Re: Request for Ambient Sulfur Dioxide Predictions in the Vicinity of F. J. Gannon Station
FDEP File Nos. 0570040-002-AV and 0570040-007-AC

SUBJECT: TECO Gannon - Follow-up to DEP's Response on Draft Title V

**Re: Tampa Electric Company
F. J. Gannon Station
Draft Title V Air Operation Permit
FDEP File No. 0570040-002-AV**

**TAMPA ELECTRIC COMPANY
COMMENTS REGARDING THE TITLE V AIR OPERATION PERMIT FOR
F.J. GANNON STATION
FDEP FILE NO. 0570040-002-AV**

F.J. GANNON STATION IMPACT AREAS

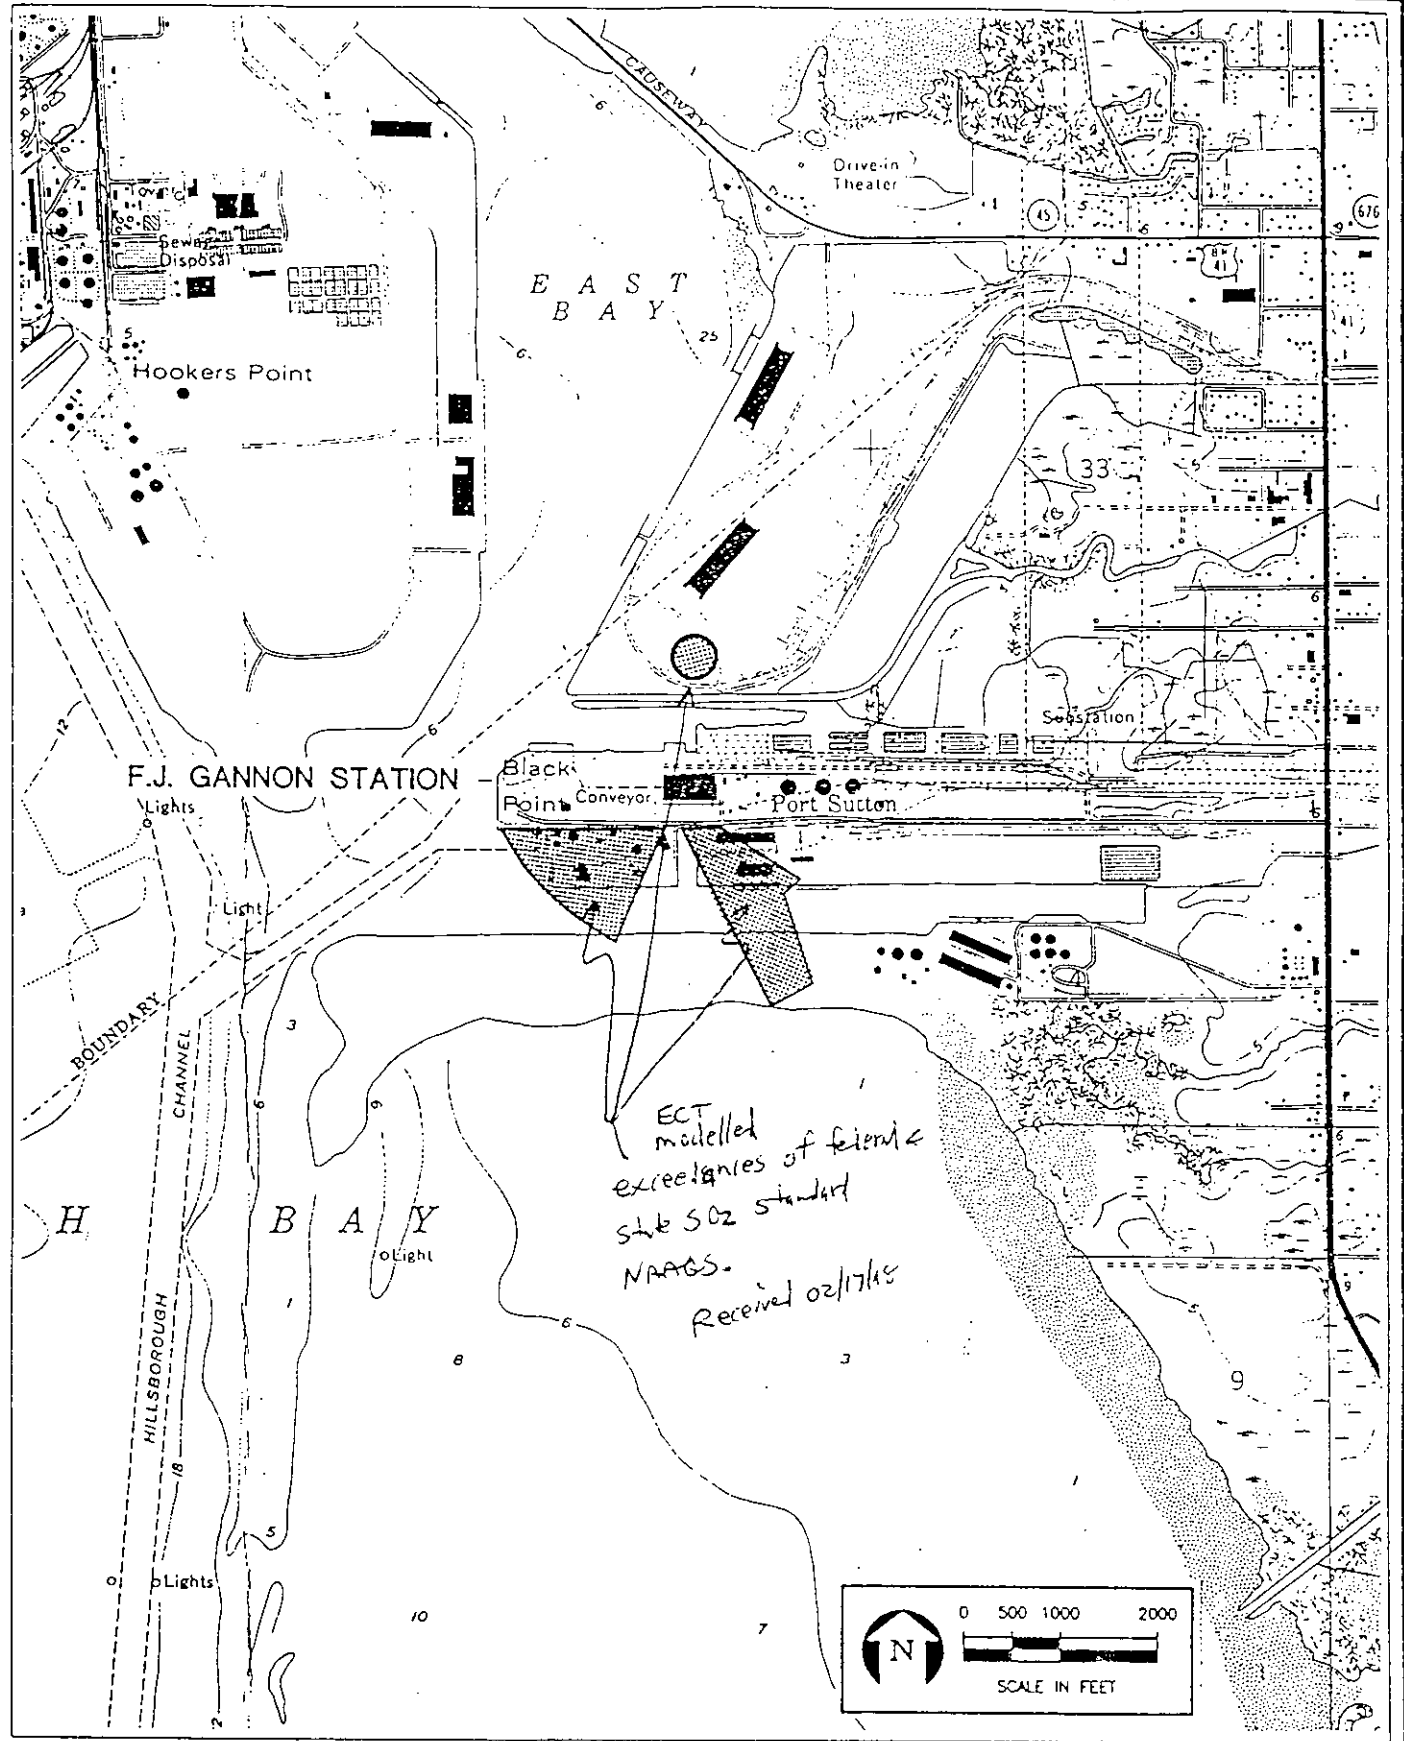
During our meeting of February 17, 1998 to discuss the Title V draft permits for the F.J. Gannon Station we discussed the likelihood of modeled exceedances of the ambient air quality standards for sulfur dioxide. We requested and believe TEC agreed to provide, more detailed modeling incorporating physical features (such as nearby buildings) capable of affecting the results.

The concern about the potential exceedances has increased because modeling performed for a project at the nearby Cargill Fertilizer Complex indicated modeled exceedances to which the Gannon Station contributes. Additionally the recent Big Bend scrubber and Gannon coalyard pollution control project (PCP) applications indicate that actual emissions at Gannon may increase. While these emissions increases appear to be within the permitted emission limits of the plant, the likelihood of actual (rather than modeled ambient exceedances) is increased.

The information needed is similar to what was submitted for the Big Bend Station in March. Please provide the requested information for the Gannon Station by October 30. If you are unable to provide it, please submit the data on the physical details of the plant in a format compatible with the Building Profile Input program (BPIP) to determine the appropriate downwash parameters for ISCST3. Please include a detailed map for the Gannon Station similar to the one provided for the Big Bend Station showing the location of all of the fence line receptors used in the air quality impact analysis.
